W39 APARTMENTS

6901 MLK JR. WAY SOUTH, SEATTLE, WA

DPD Project #3019452

Recommendation Meeting
Southeast Design Review Board
November 14th, 2017

VIEW OF THE RESIDENTIAL AND RETAIL ENTRANCES AT MARTIN LUTHER KING JR. WAY SOUTH

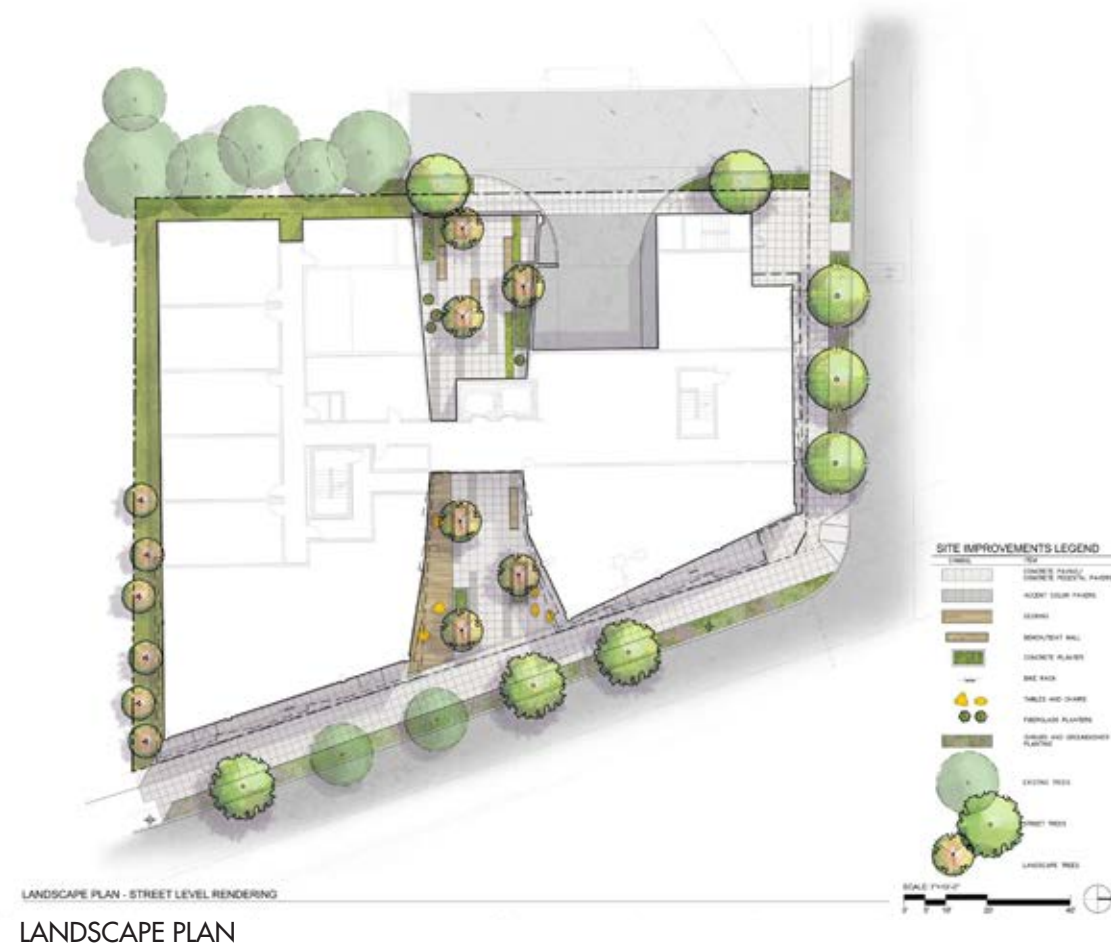
a. The Board supported the retail plaza location fronting off M L King Jr Way S since the location allows for the opportunity to activate the street edge. The Board expressed concern about the proportions of the residential plaza to support the functions of the development. The design of the residential courtyard space should maximize usable space for residents. The Board recommended further studying and developing the proportions of the plazas. Guidelines DC3-A, DC3-B)

RESPONSE: The public plaza is located adjacent to MLK Jr Way S in order to promote an activated plaza for the community as well as spill out space for both the residential and retail tenants. This space will have landscaping elements, seating and gathering space. The residential plazas will be located on level 2 along the west side of the building as well as on the roof top. The level 2 patio is raised above the street level to allow for a more secure space. This area will be designed with landscaping, seating and gathering space as well as a BBQ area for the residents. The roof top plaza will have seating and gathering spaces along with enhanced landscaping and green roof features. This area will also have BBQs for the residents.

LANDSCAPE PLAN

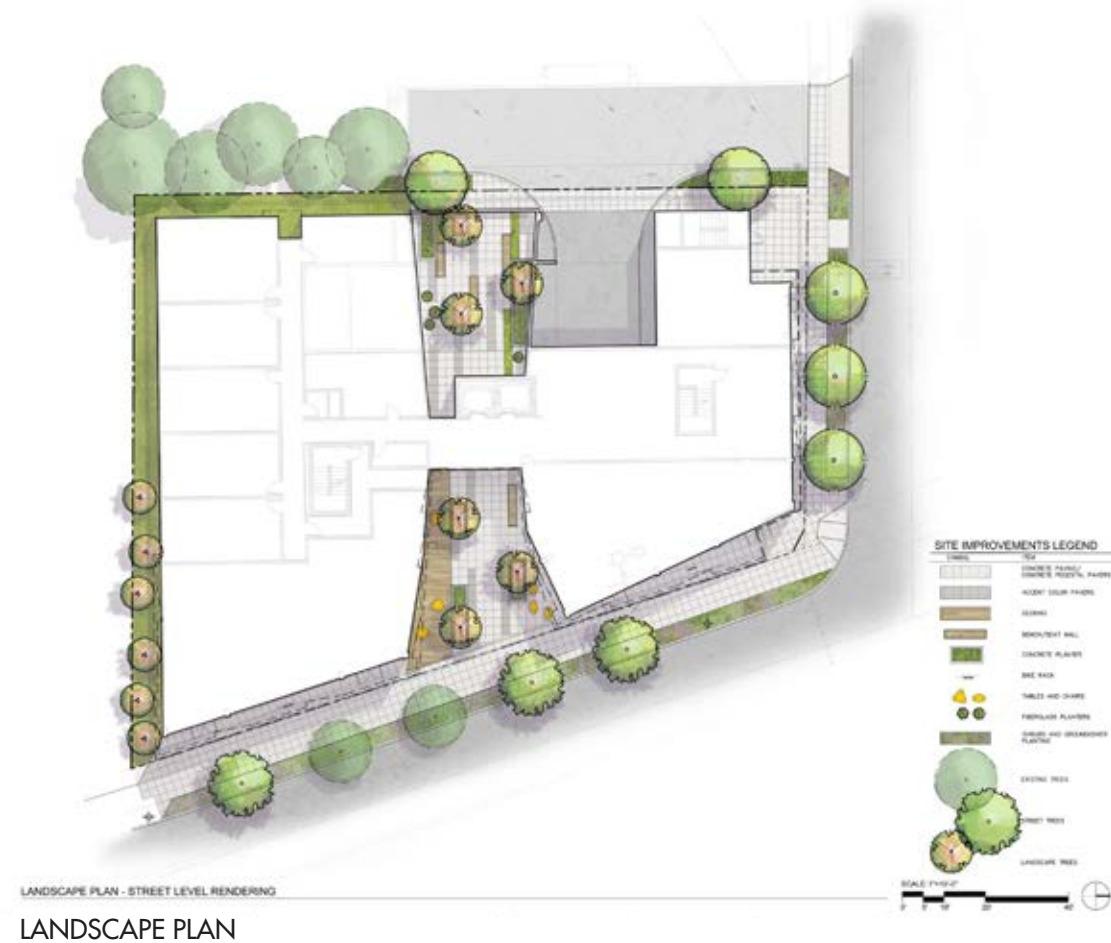
b. Acknowledging that the shadow study demonstrates the courtyard spaces will be in shade for the majority of the time, the Board questioned the viability of the planting. For the next meeting, provide a more detailed landscape plan which addresses the viability of vertical planting in shade. (Guidelines CS1-B, DC3-A)

RESPONSE: A more detailed landscape plan has been provided per the Board's recommendation.
